Saint Priest, October 22, 2012

**Subject: URGENT – RECALL NOTIFICATION LETTER**  
**Medical device: Integra CT-compatible Intubation Head Ring Assembly**  
**References: HRAIM**  
**Legal Manufacturer:**  
Integra Burlington MA, Inc - 22 Terry Ave, Burlington, MA 01803 - USA  
**Devices affected: all units manufactured since February 7, 2006.**

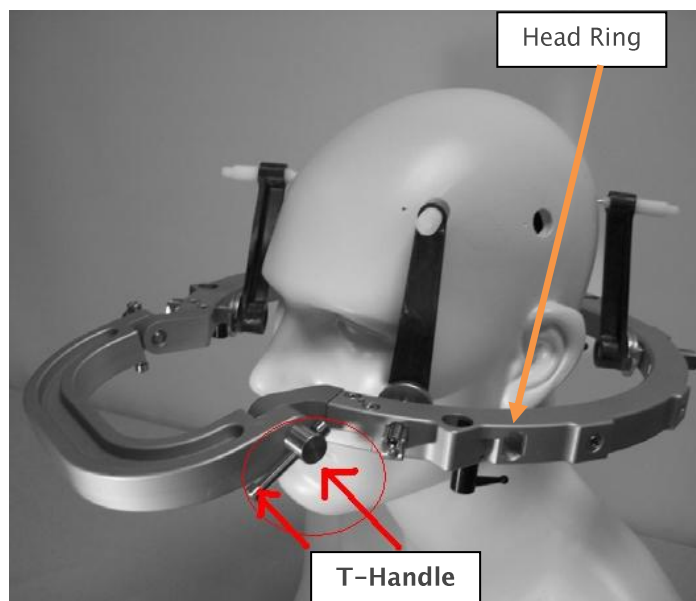
Integra LifeSciences Corporation (Integra) has determined that when the T-handle on the **Integra CT-compatible Intubation Head Ring Assembly (HRAIM)** intubation hoop is tightened on some units, it may stop in a vertical position that prevents the *CRWPRECISE* (also known as the CRW Precision Stereotactic Frame) and *CRWASL* (CRW Arc System) from being properly seated on the head ring (please see picture below). This issue is due to the screw head present in the T-handle.

Following complaints received and in order to prevent any occurrence of this issue, Integra has modified the screw head on the HRAIM. Moreover, Integra is taking a very conservative approach to resolve this inconvenience for its customers by initiating a voluntary Field Safety Corrective Action to provide you with the information needed to have the current screw head replaced with the new one.
